PLAN REVIEW COMMENTS

APPLICATION NUMBER: ALT 208-22
DATE RECEIVED: November 3, 2022
LOCATION: 27 Sturgis Road
SBL: 7.E/3/6
APPLICANT NAME: Andrew & Amy Korb
APPLICANT ADDRESS: 27 Sturgis Road
Bronxville, NY 10708

DESCRIPTION OF WORK : To construct a 1 story addition with finished basement at the rear of the residence. Addition will include a new master bedroom suite, expanded kitchen and family room.

PROPOSED ADDITION FOR: KORB RESIDENCE
 27 STURGIS ROAD
 BRONXVILLE, NY

Dwg. Name: **SITE PLAN**

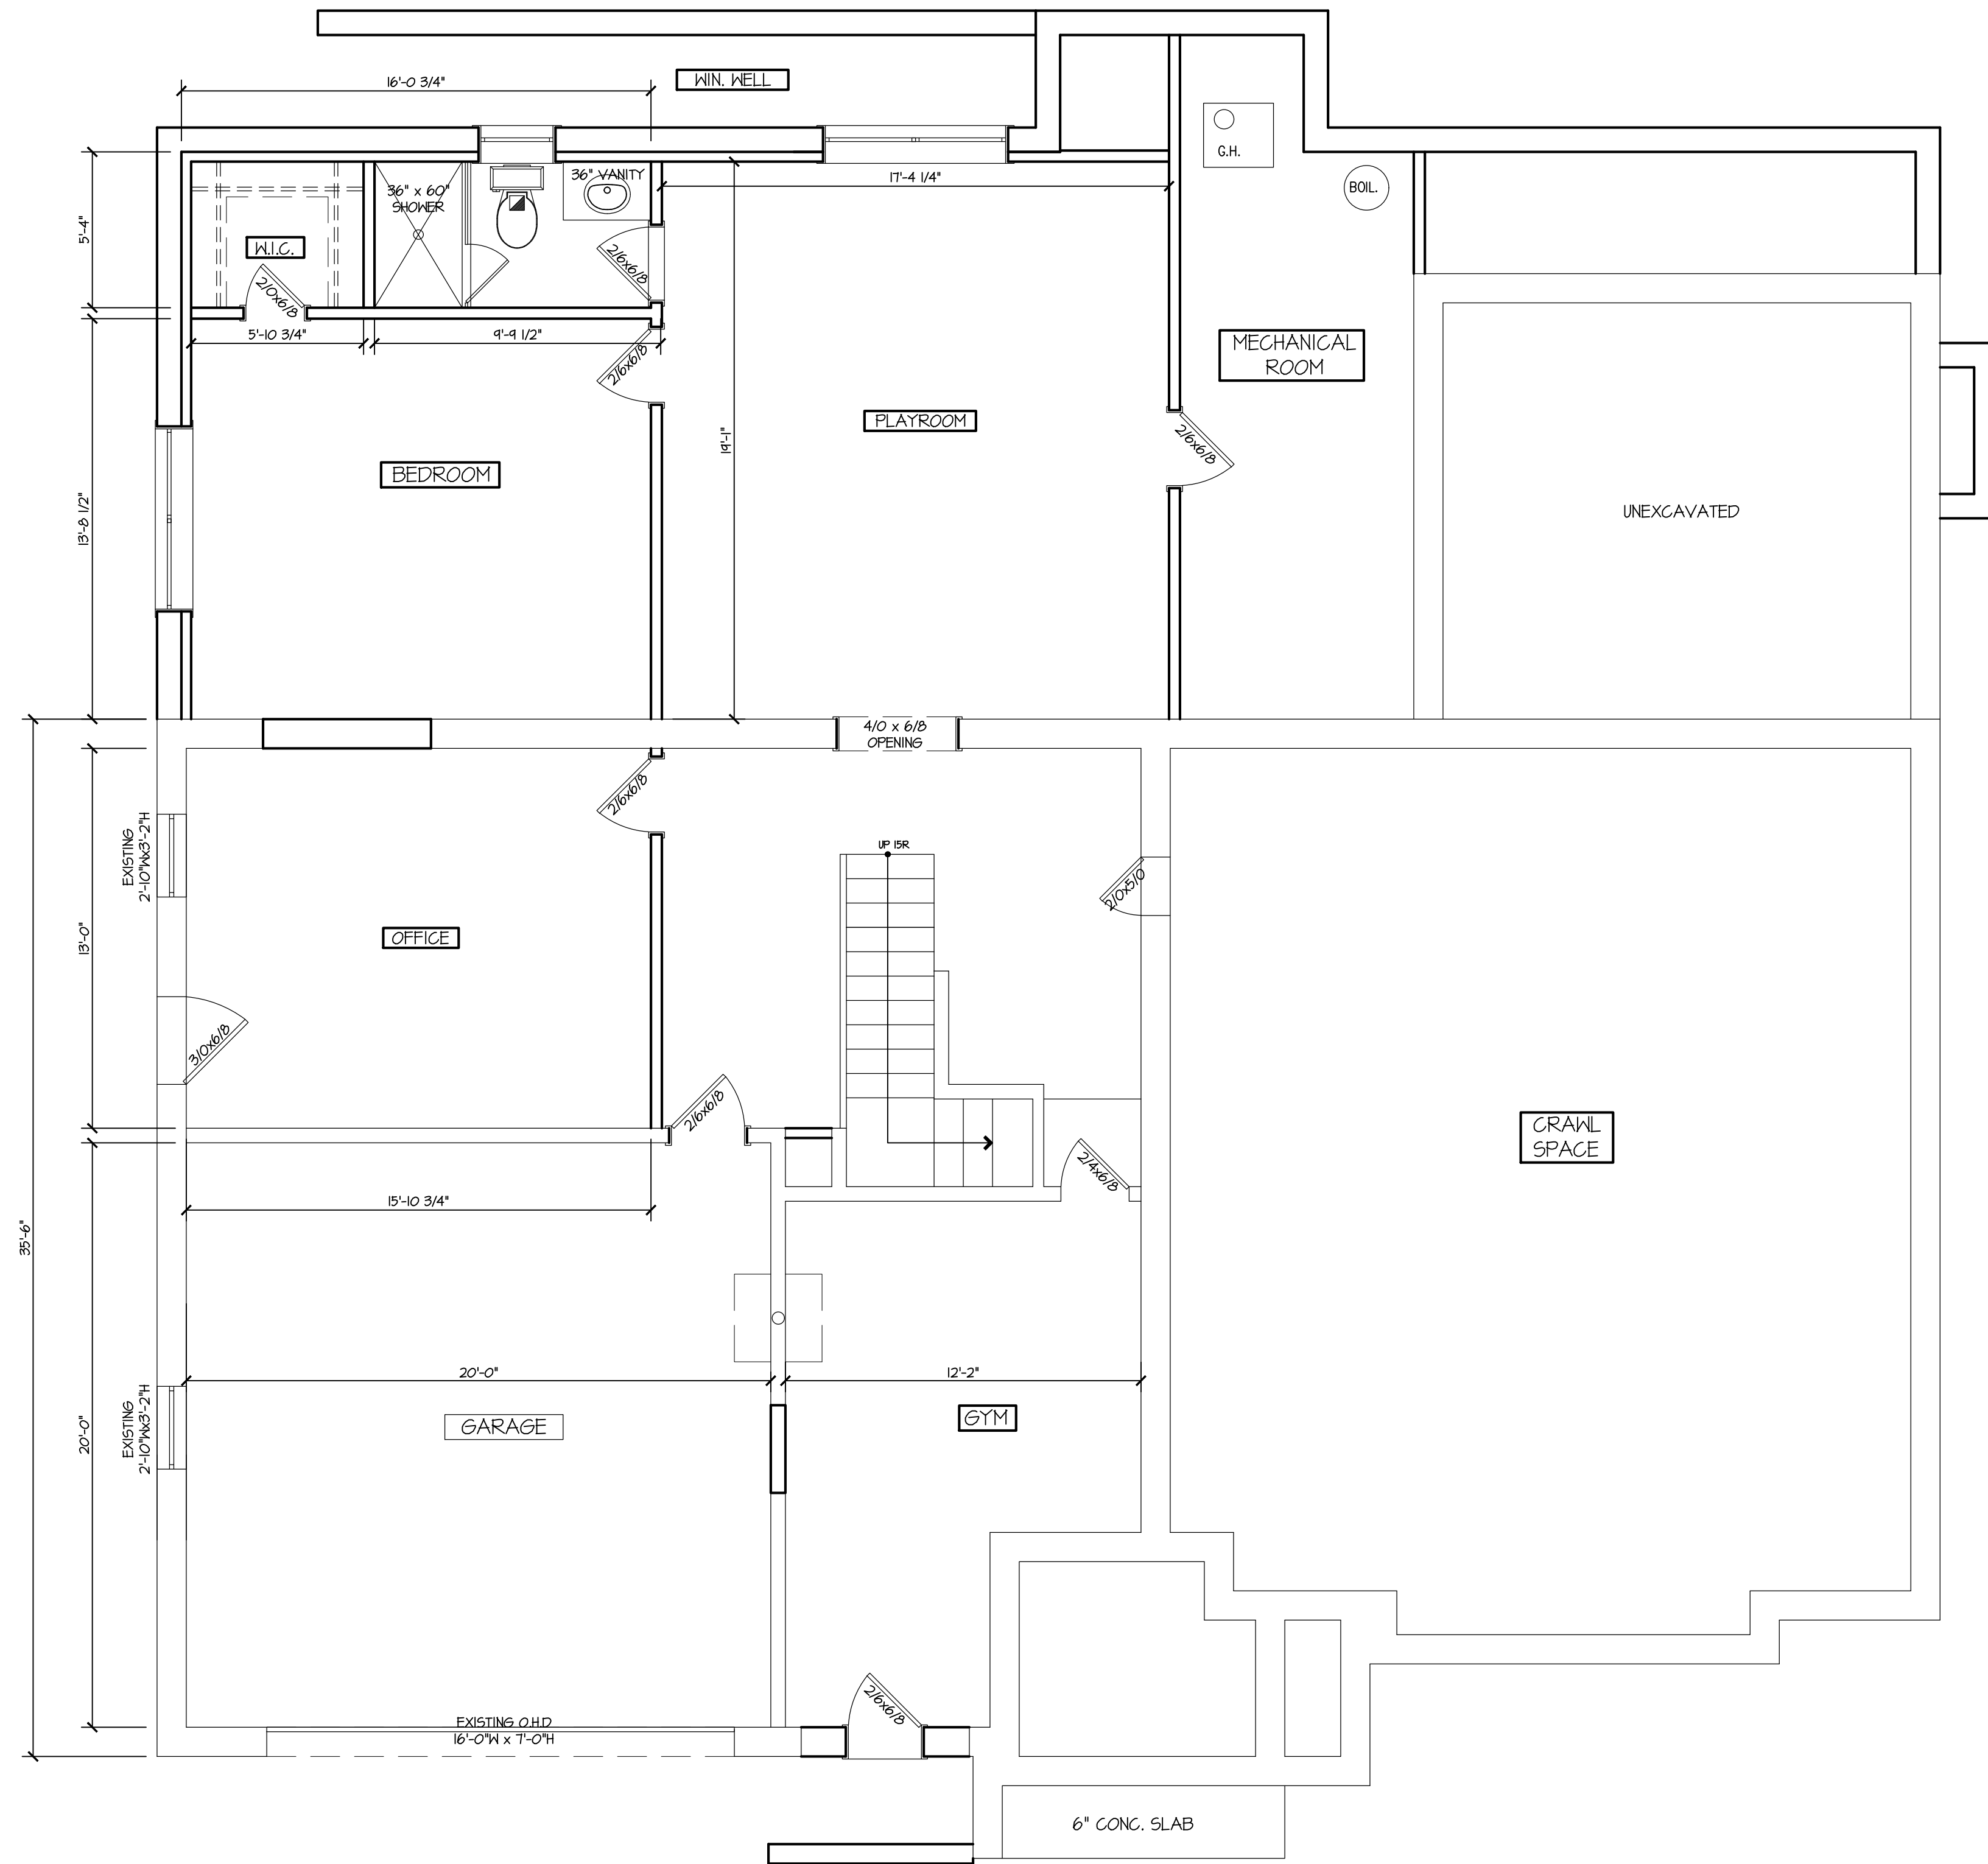
- 1) 310-25 Side Yard 1 (left side) Required 15'; Existing - pre-existing non conforming - 14.8'; proposed - increase in non-conformity 14.8'; variance required 0.02'
- 2) 310-09 D (2) Side Yard 2 (right) Required 15'; Existing pre-existing non-conforming 14.9', proposed 12.95', variance required - 2.05'
- 3) 310-09 D (2) Combined side yard - Required 35', Existing 29.7', proposed 27.75', variance required 7.25'
- 4) 310-26 D Material Alteration - Increase in FAR - Allowed - < 30%; proposed increase 42.5% - proposed work considered a material alteration - planning board approval required for site development
- 5) 310-09 E Building coverage - Allowed 22.5%, existing 16.2%, proposed 30.9%; Variance Required - 8.4%
